Subject: MHI's Response to US-APWR DCD RAI No. 526-4121 REVISION 2

Response to Request for Additional Information
No. 526-4121 Revision 2

RAI NO.: 526-4121 REVISION 2
SRP SECTION: 09.03.02 – Process and Post-Accident Sampling Systems
APPLICATION SECTION: 9.3.2
DATE OF RAI ISSUE: 02/01/2010

Sketch 1 – ESF Room Leak Detection System Schematic

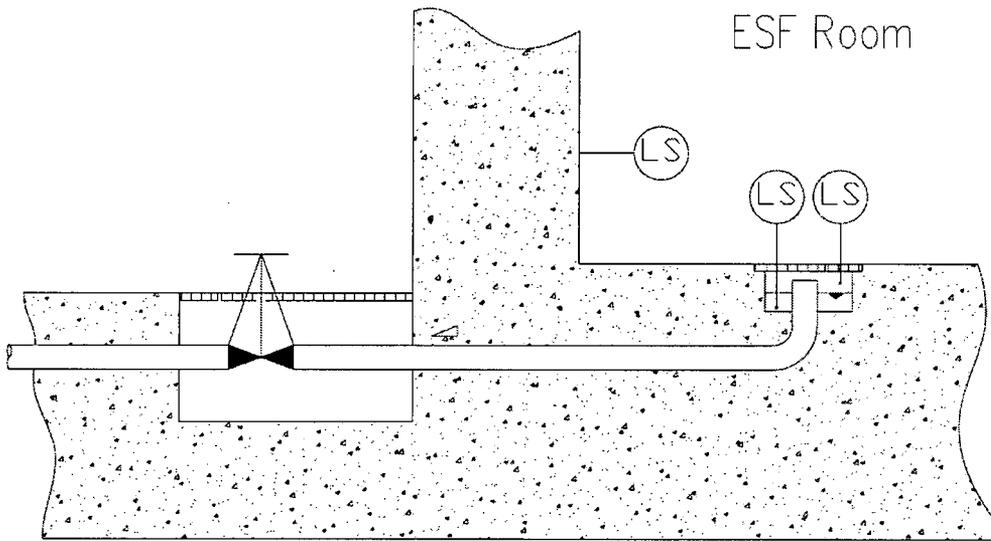
1. Provide the actual leakage rate sensitivity, in terms of gallons per minute or gallons per hour, of the leakage detection system for the ESF rooms, or explain why it is not necessary to specify the leakage rate sensitivity.
2. Can the ESF leakage rates be characterized in a post-accident situation using the leakage detection system described?

1. The leak detection system used for the ESF rooms is shown in sketch 1 attached. The leak detection system includes a leak accumulation pit equipped with two level switches at different levels and a drain pipe. The accumulation pit is approximately 1 foot 8 inches wide by 1 foot 4 inches long by 6 inches deep, and has a liquid volume about 1.1 cubic feet. The leak detection system is located inside each ESF room. When liquid accumulates to a predetermined liquid level (approximately 1.5 inches from the pit bottom), the level switch will

initiate an alarm in the main control room and starts timing the leak. When liquid reaches to a predetermined liquid level of the second level switch (approximately 3 inches from the pit bottom), the level switch will initiate an alarm in the main control room. This signal allows determination of leakage rate based on the accumulation rate. Should liquid continue to accumulate, it will be trapped inside the tank cubicle and flooding inside the cubicles may occur. A separate level switch is mounted on the inside wall near the floor of the ESF room. This third level switch detecting liquid will initiate an alarm in the main control room. The level switches are accurate to approximately +/- ¼ inch liquid level measurement. This design approach enables the plant operators to determine and/or evaluate the extent of conditions and perform analysis before corrective actions are implemented.

The above approach detects the predetermined liquid levels and measures the accumulation rate, from which the actual leakage rate can be determined. The sensitivity of the leakage rate is correlated to the liquid volume between the setpoints of the level switches and the accumulation time. In this design the difference in height between the level switches is 1.5 inches, which represents about 7.9 liters.

Sketch 2 – CVCS Tank Room Leak Detection System Schematic

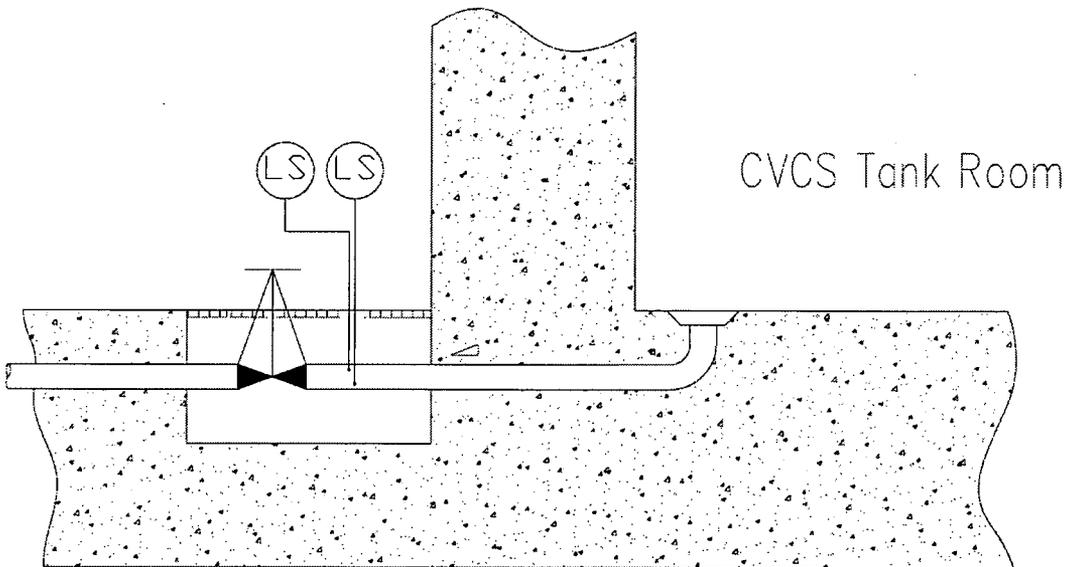
1. Provide more detail on the leak detection system for the CVCS.
2. Since the response to RAI 461-3686, Question 09.03.02-12 Item 4 indicated that the CVCS is to be included in the scope of the leakage monitoring and prevention program, the staff requests the applicant remove the statement from the DCD that, "Therefore, the provision for a leakage detection and control program in accordance with 10 CFR 50.34 (f) (xxvi) does not apply."

1. The leakage detection system design for the CVCS systems takes into consideration the possibilities of large leakage from the tanks in the CVCS. Failure of these tanks could flood the floor drain sump tank area if not carefully controlled. Hence the design uses level

switches inside a slightly sloped drain pipe with a normally closed valve at the down slope side (Refer to the attached sketch 2).

When liquid accumulates to a predetermined liquid level, the first level switch sensing element which is inserted into the pipe will initiate an alarm and starts timing the leak. A second level switch is installed upstream of the sloped drain pipe with sufficient volume for liquid accumulation. When liquid continues to accumulate to the next level, the second level switch will initiate an alarm in the main control room. This signal allows determination of leakage rate based on the accumulation rate of the liquid. Should leak continues to accumulate, the liquid will be trapped inside the tank cubicle and flooding inside the cubicles may occur, if no other corrective actions are implemented. This design approach enables the plant operators to determine and/or evaluate the extent of conditions and perform analysis before corrective actions are implemented.

The above approach detects the predetermined liquid levels and measures the accumulation rate, from which the actual leakage rate can be determined. The sensitivity of the leakage rate is correlated to the sensitivity of the level switch. It should also be noted the two level switches can also be served as redundant leak detection instruments.
